Agenda item 6.2

**Ministerial Planning Referral: TPMP-2019-20
600 Lonsdale Street, Melbourne**

DELEGATE REPORT

| Address: | 600 Lonsdale Street, Melbourne |

Figure 12 ground floor plan. Source: SOM Architects Pty Ltd and Fender Katsalidis Architects Pty Ltd discussion plans dated 5 March 2020

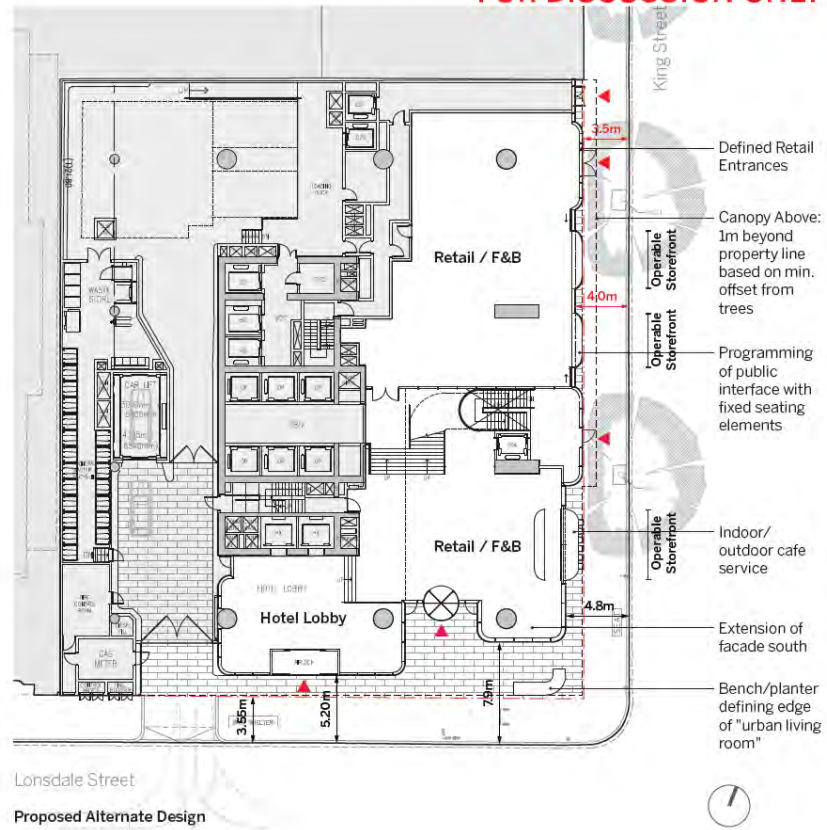
- The ground floor layout and public interface in the 05 March 2020 discussion plans has greatly improved. There is a much tighter relationship of activated spaces and

- The 'urban living room' in 05 March 2020 discussion plans has been positively redesigned in line with the King Street improvements.
- Recommend the main office entrance not to be recessed. This recess space is potentially an unsafe nook and litter trap. By aligning the entrance with the set-back south facade the entrance would benefit from better surveillance and visibility to the street corner.
- The corner element 'Bench/Planter' is supported. Preference this to a bench, not a planter, as the size is very limited and vegetation might fail on this busy street corner.

- Support the greening strategy of the building façade as it both breaks up the bulk of the building mass and contributes to green amenity for the building and the streetscape.
- The greening strategy for the ground floor appears to rely on informally positioned hanging plants which are in contrast with the strong structural green elements of the façade above.
- Advocate for more strong interaction of the greening surfaces and amenity spaces with the streetscapes of King Street and Lonsdale Streets. It is recommended to physically bringing green elements / green walls down to ground level. This would further 'ground' the building into the streetscape. The ground floor and hanging plants should be reconsidered.

- a. The changes shown in the discussion plans dated 05 March 2020 but amended to show:
 - i. The green façade continuing to the ground level
 - ii. The office entrance glazing aligned with the glazing line east of the office entrance

Figure 17 proposed building massing. SOM Architects Pty Ltd and Fender Katsalidis Architects Pty Ltd dated 16 September 2019

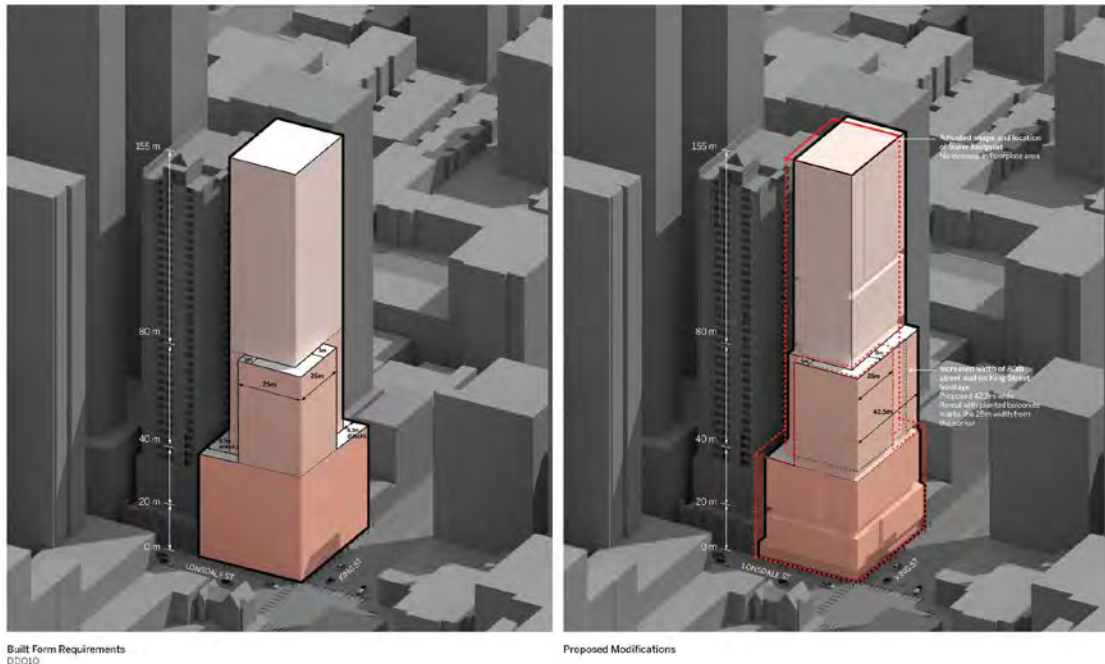
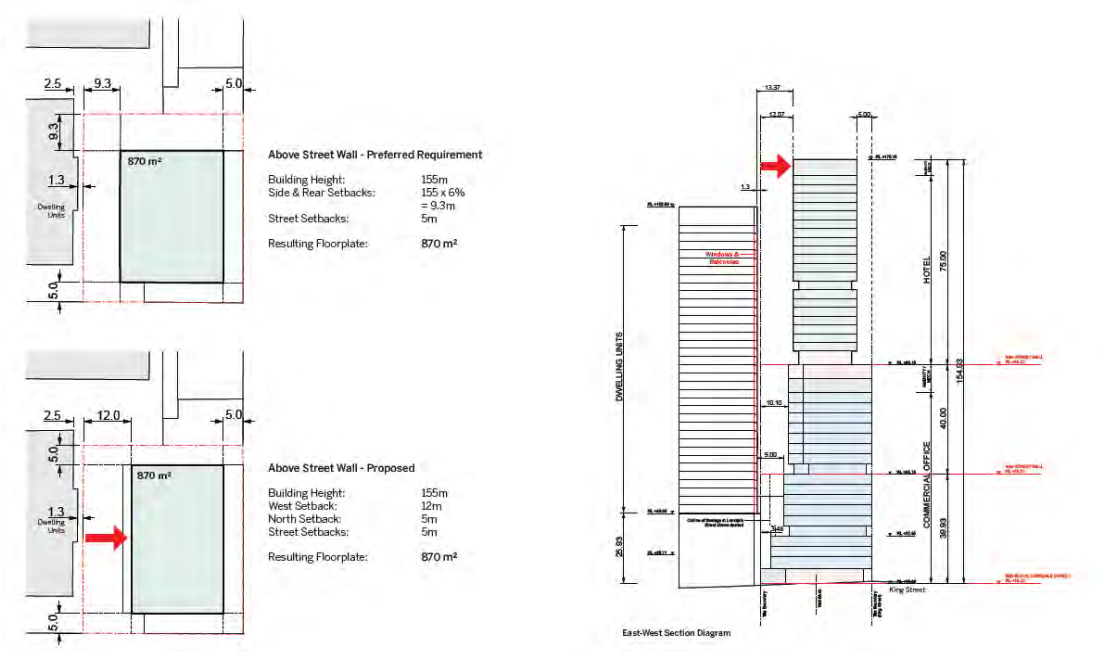
The reduced floor area cannot be redistributed within the proposed levels. The proposal seeks the maximum built form envelope allowed under the modified requirements of DDO10 with the exception of the 3.57 metre podium setback on the northern boundary and the

The northern setback allows for the northern façade to be architecturally articulated and also provides amenity by way of light and air to the proposed office floorplate. The western setbacks provide a better amenity outcome to the existing apartment building at 618 Lonsdale Street, Melbourne and a more efficient rectilinear floor plate for the proposal.

The only option for the proposal to regain the loss in floor area would be to add an additional level to the tower element of the proposal whilst also providing compliant setbacks.
